ADDENDUM #4

Issued: December 9 , 2025

PROJECT:
CHAR-LAN RECREATION CENTRE ROOF AND SIDING REPLACEMENT

TITLE:
ADDENDUM #4

1 PART WEST ELEVATION - NEW
 AD1.1 3/32" = 1'-0"

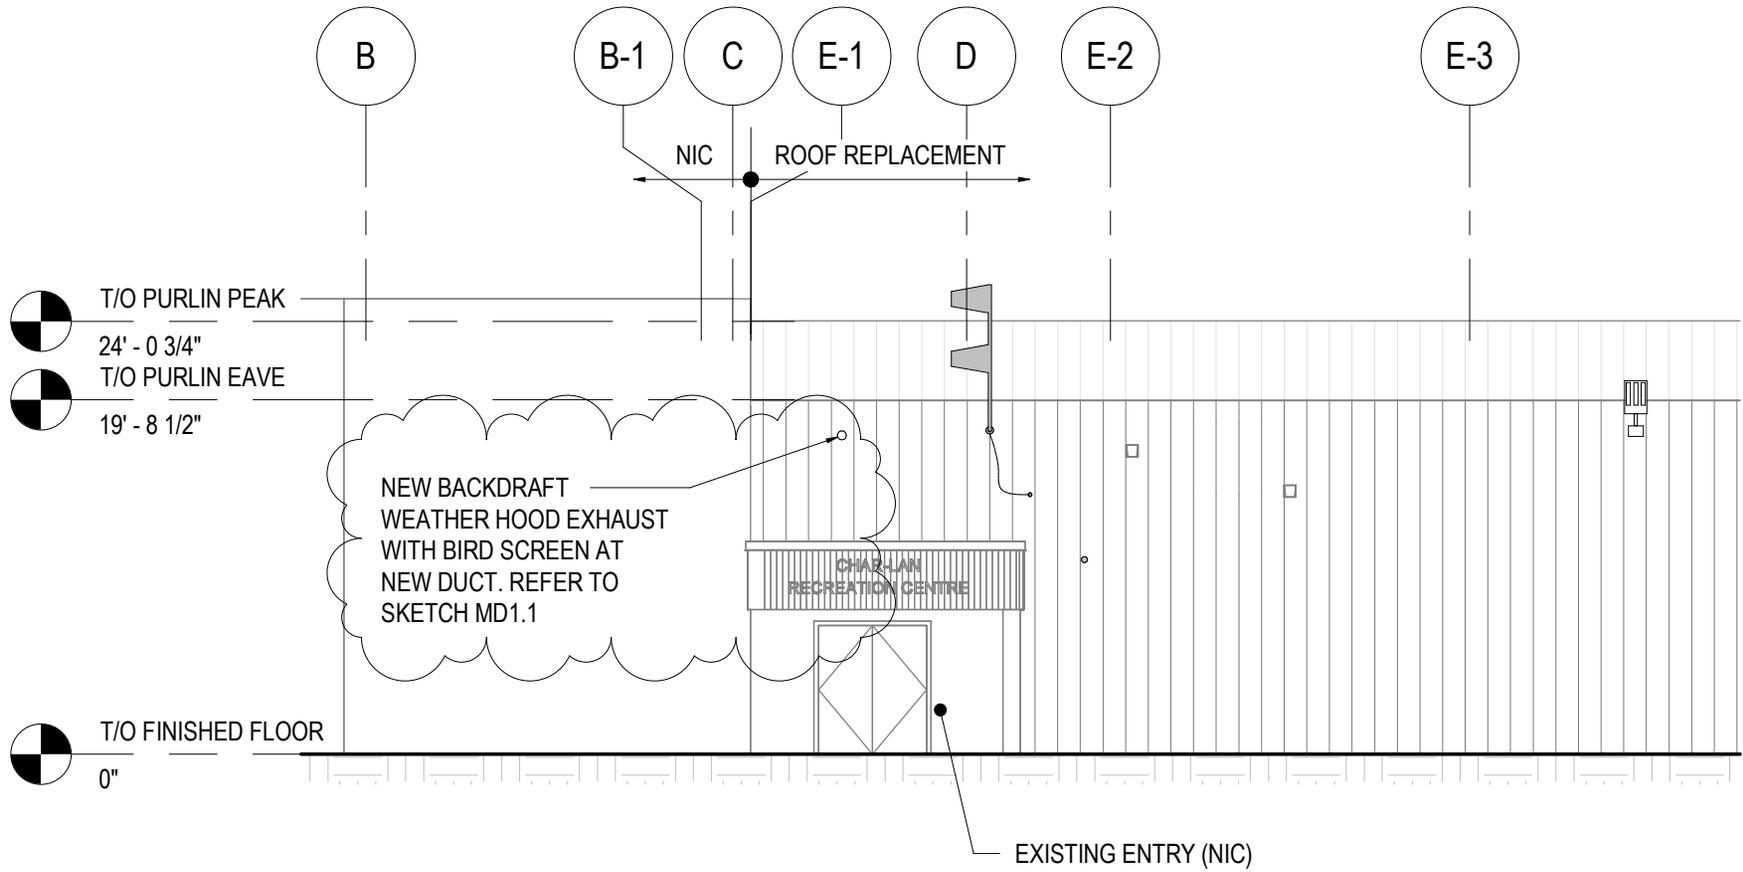
4. Drawing A2.1 – NEW EXTERIOR ELEVATIONS

Revise per attached sketches AD1.1 and AD1.2

DRAWING NO.
AD1.3

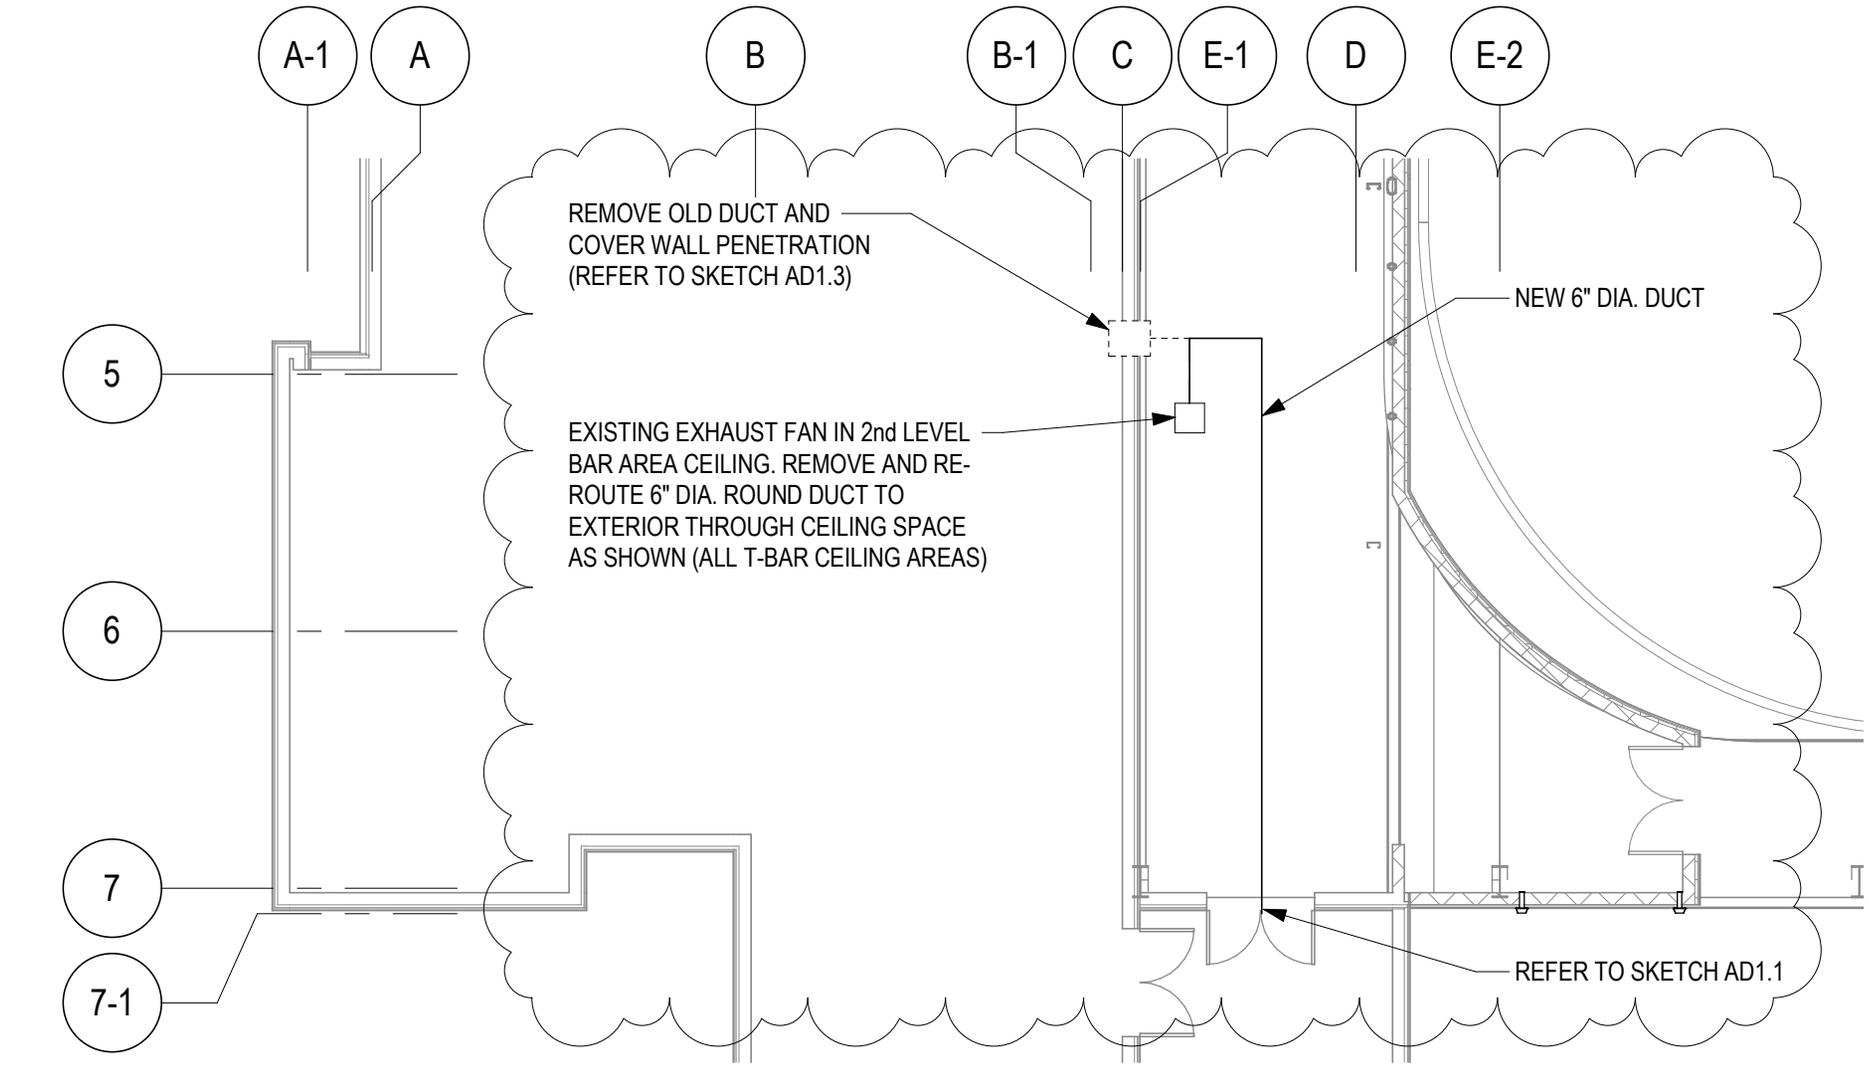
Add photos per attached sketch AD1.3

1 PART FLOOR PLAN - MECHANICAL
 MD1.1 3/32" = 1'-0"

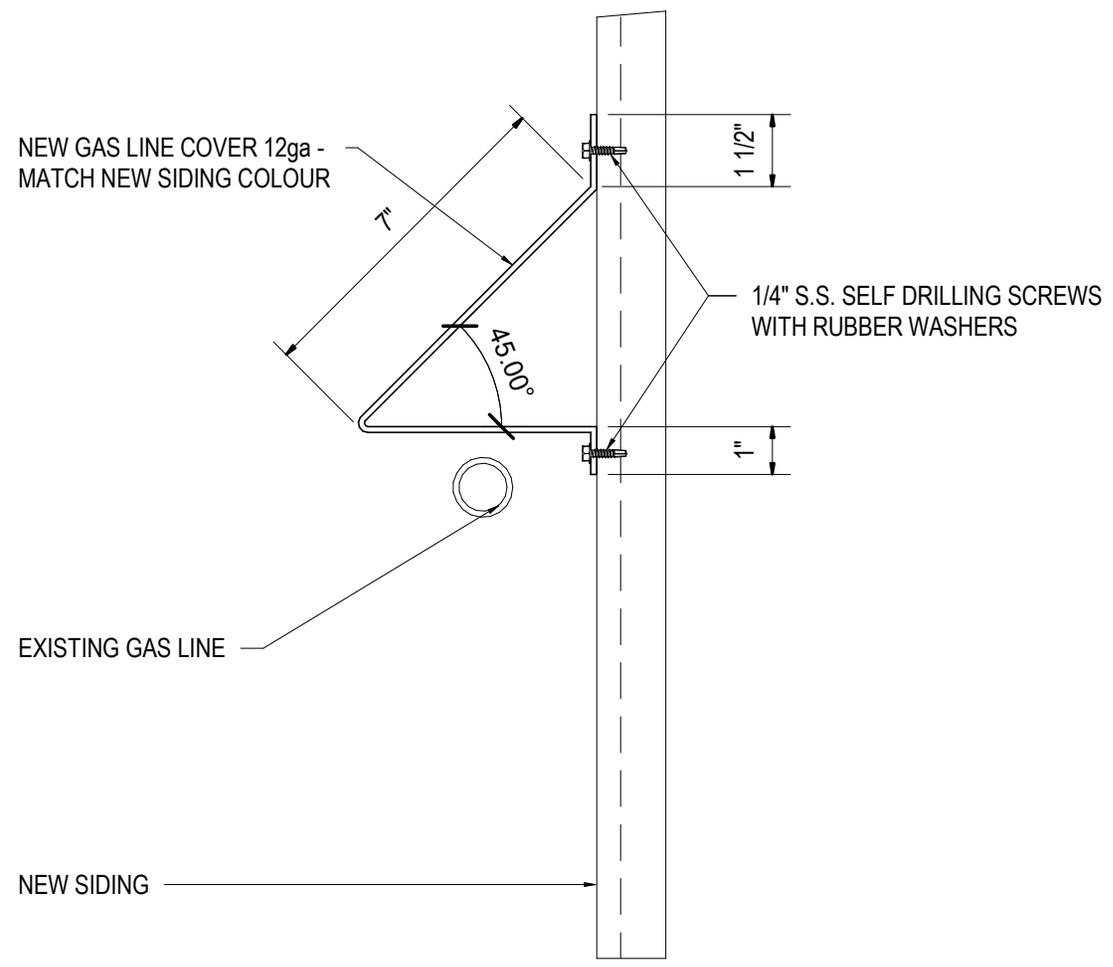
5. Drawing M1.1 – ICE RINK HVAC LAYOUT

Revise per attached sketch MD1.1
